MAJOR PROJECT ASSESSMENT:
Residential Development Buildings 6, 9 & 10
61 Mobbs Lane, Epping- Former Channel 7 site
MP11_0048

Director-General's
Environmental Assessment Report
Section 75I of the
Environmental Planning and Assessment Act 1979

May 2012

Figure 10: Amendments to Storey Height of Building 9 (Source: PPR and Additional Information Report)

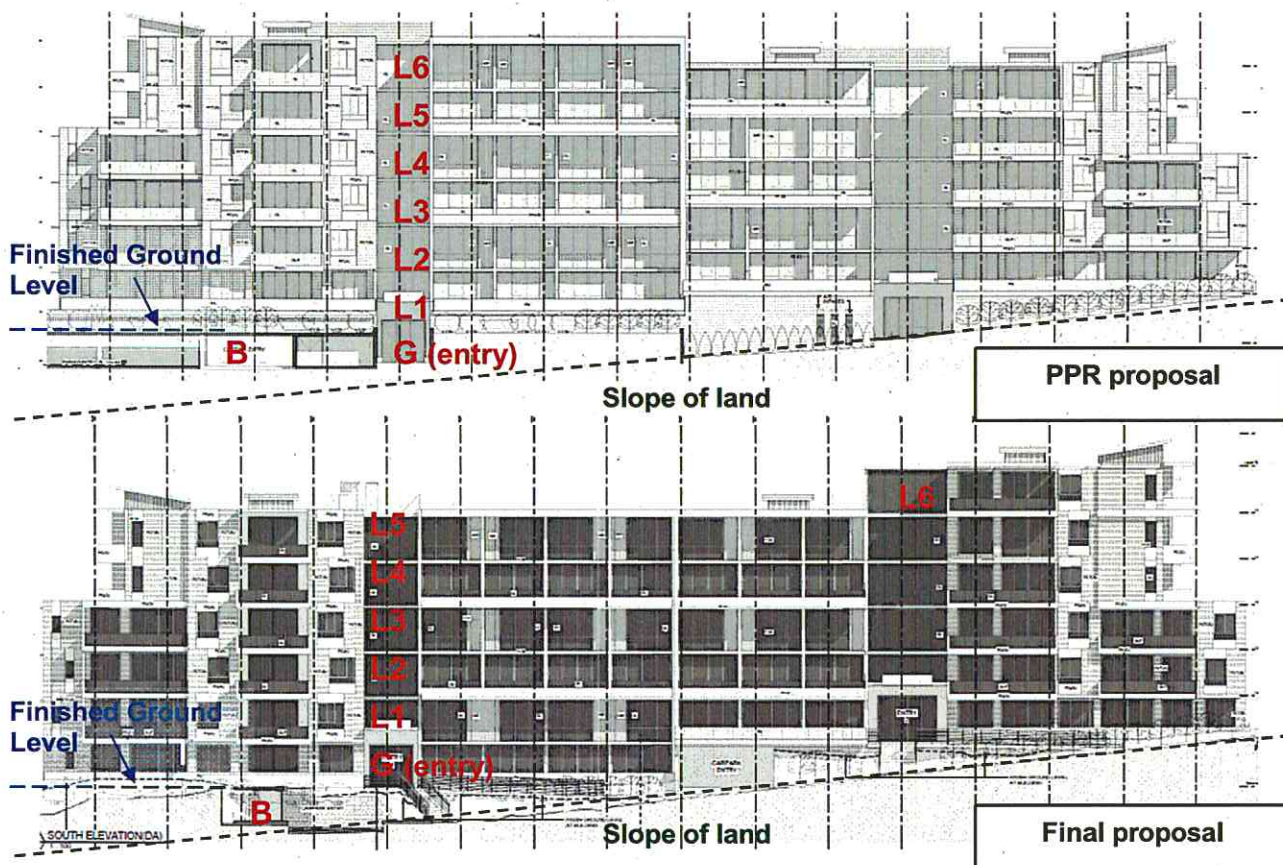
Consistency with building height limits was achieved following amendments contained within the 'Additional Information Report', which reduced the height of Building 9 from that originally proposed in the EA and PPR. Due to the topography of the land, the western section of Building 9 appeared as a 7-storey element and the basement level protruded above ground level, which raised concerns from the department and council.

Accordingly, amendments were made to Building 9 to ensure basement levels were consistent with the concept plan requirements (to be no higher than 1.2m above ground level) thereby reducing the overall storey height of the building (Refer Figure 10 above). The resulting elevational changes include separate car parking entrances split over two levels and stairs and ramp access to the main pedestrian entrances. The finished floor levels at the western end of the building will be above the natural/average slope of the land to ensure the building appears as a 6-storey building as the land slopes downward and westward along Mobbs Lane. The height of plant equipment at the roof level of Building 6 was also amended by the proponent to reduce the visual impact of the proposal at roof level.

Figure 12: Building Envelope (Source: Additional Information Report)

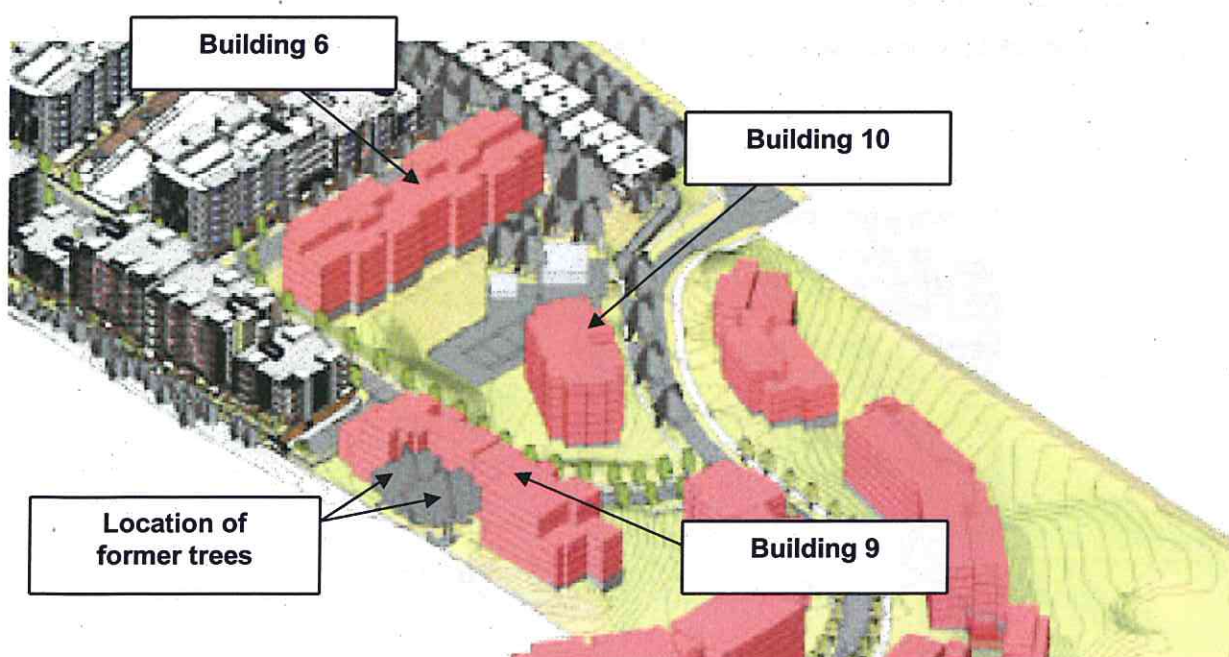
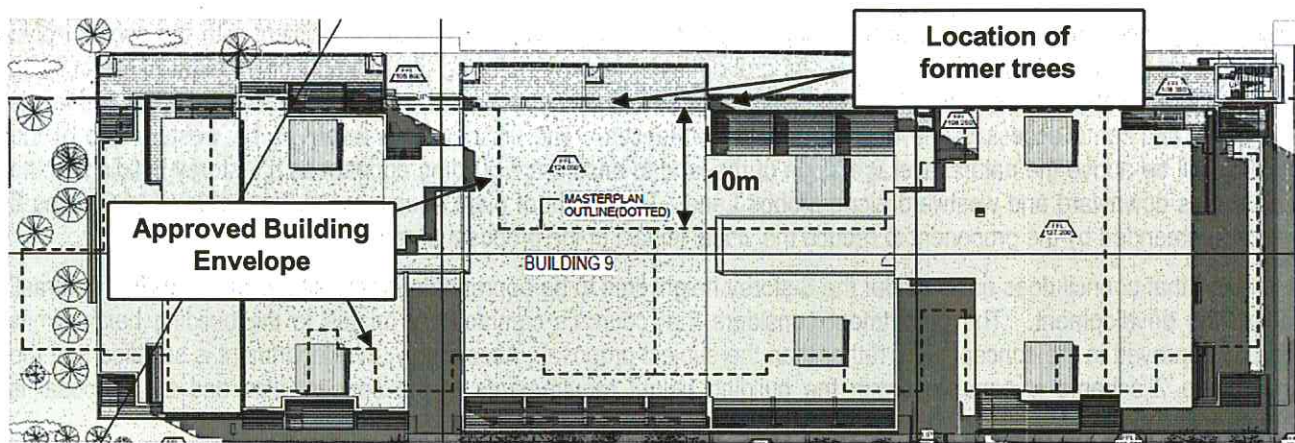
The most significant departure from the concept plan can be seen in Building 9 where the proposal exceeds the approved building envelope by 10m in the central area of the building. Figure 11 illustrates the 3D building envelope approved under the concept plan (MOD2) while Figure 12 illustrates the outline of the approved building envelope (dotted) overlayed on top of the building proposal. It can be seen that the proposal exceeds the master plan envelope in the centre of the building where the depth of the building narrows to approximately 11m.

In this instance, the infill of this envelope area is considered acceptable by the department. The building envelope was originally designed to accommodate two mature trees along the northern boundary of the site, however the removal of these trees was approved by the department in the Early Works approval. As the proposal does not exceed the established building line facing the northern boundary, it is considered that the infill development would have little impact on the site as a whole and little visual impact along the northern boundary. The adjoining site is occupied by the horticultural campus of Ryde TAFE. Landscaping provided will ensure visual amenity is retained along the northern boundary.

Figure 13: Building 9 setback to northern boundary (Source: Additional Information Report)

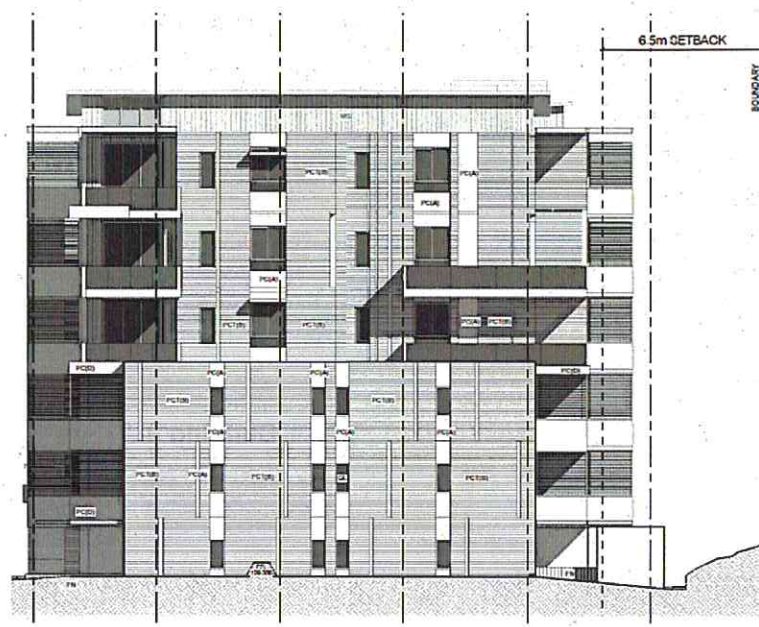
The concept plan approval does not clearly specify a setback distance for any residential buildings although a setback distance of 6.5m to the northern boundary was established by the adjacent Building 8 in the Stage 1 project approval.

Building 9 is sited to be generally consistent with the 6.5m setback and is therefore considered acceptable by the department. It is noted that the 6.5m setback is encroached by northern facing balconies and pergolas by 1.2m in two locations, however the overall impact of this encroachment is not considered to be significant. The visual impact of the balconies is likely to be minimal and given that the nearest TAFE or residential building is located some 80m away this encroachment is considered acceptable. At ground level, private spaces of ground floor dwellings also encroach the 6.5m setback, however this is consistent with Building 8 which has already been approved, and there would be no resultant impact on neighbour amenity.

Figure 14: Building depths for Building 10

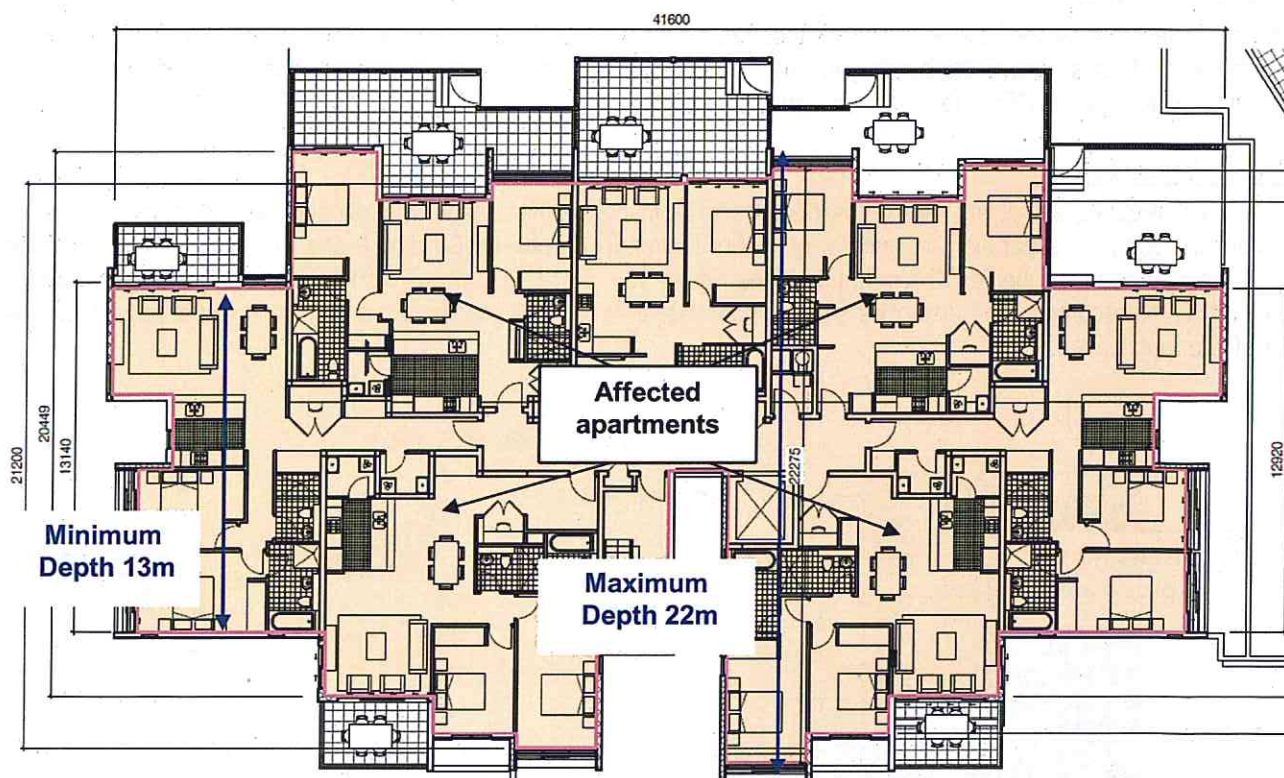
As shown in the above table, all three buildings feature varying building depths and generally range from between 15m to 22m. Columns 4 and 5 have been included to illustrate and quantify the degree of non-compliance with the 18m depth requirement. Where building depths reach 22m, this equates to a building depth 22% greater than the RFDC recommendation. Further illustration of building depths is seen in Figure 14 below:

In justifying the proposed building depths, the proponent stated that greater depths were required to accommodate adaptable units and to comply with fire egress requirements under the BCA. However, a review of building depths found no significant differences resulting from the inclusion of adaptable units, while the maximum BCA distance required from an apartment to a fire exit is not responsible for the proposed building depths, which exceed the 18m guideline by up to 4m. Accordingly, the department does not consider the proponent's justification to be adequate.

Figure 15: Building separation between Buildings 9 & 8 (Source: Additional Information Report)

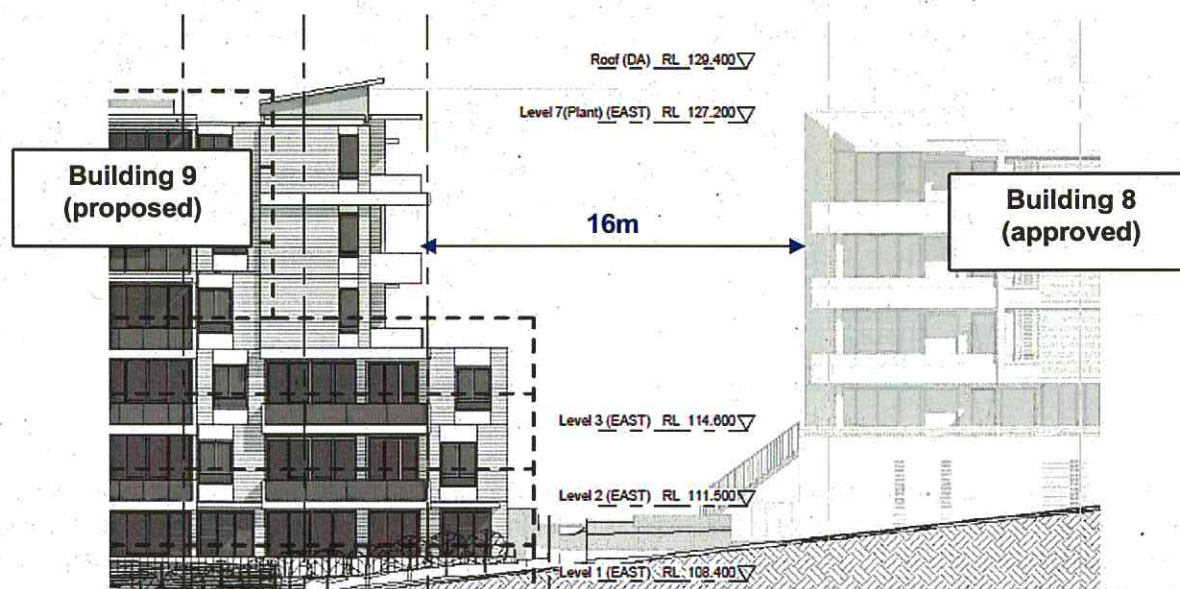
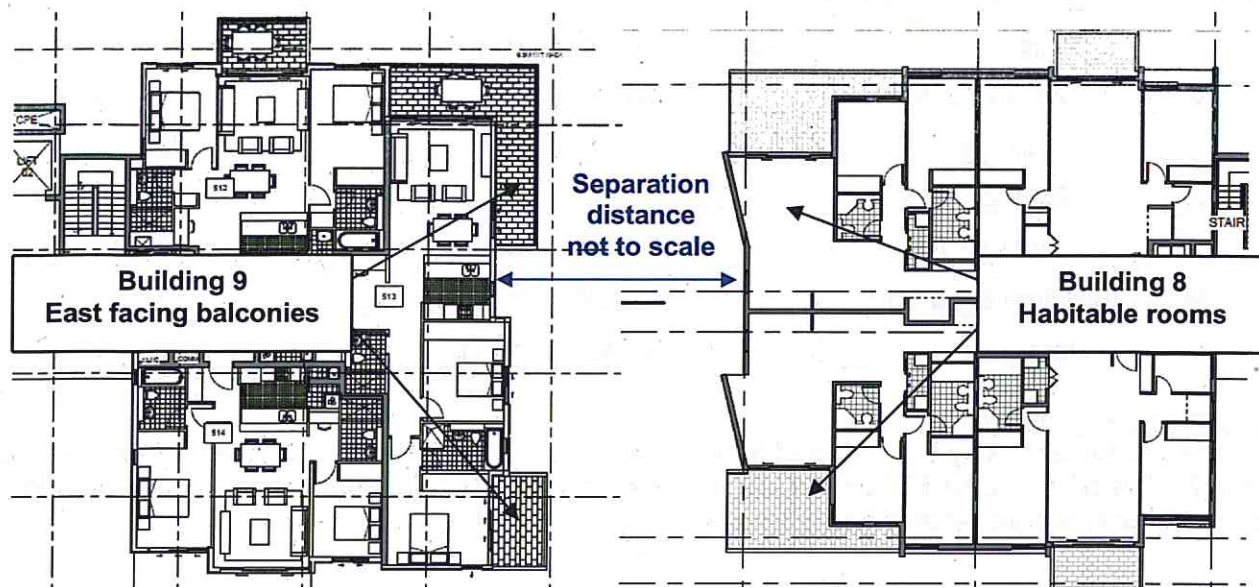
The RFDC requires a building separation distance of 18m between habitable rooms/balconies for buildings over 5-storeys in height. A separation distance of only 16m is proposed between Building 9 and Building 8 (Stage 1) at the higher levels, less than the RFDC requirement (see Figure 15). The RFDC allows for flexibility with building separation so long as the recommended distances shall demonstrate that daylight access, urban form and visual privacy can be satisfactorily achieved.

An inspection of the approved internal floor plans for Building 8 reveals that habitable rooms exist on the western elevation (see Figure 16). Building 9 proposes east facing balconies, directly facing the habitable rooms in Building 8. As a result, the department requested the proponent address the RFDC requirement and the department's concerns regarding amenity. Upon further consideration from the proponent, it was stated by the proponent that the RFDC requirements were complied with, however this is not reflected in the submitted plans. Therefore, given the clear non-compliance with the RFDC and the absence of any mitigation measures to ensure visual privacy, the department recommends design modifications to Building 9 to ensure the 18m distance is complied with.

- Amendment of east facing apartments of Building 9 facing the habitable rooms/balconies on Building 8 to ensure satisfactory residential amenity and compliance with the RFDC
- Amendment of basement car parking layout to ensure sufficient car parking in accordance with the approved concept plan.
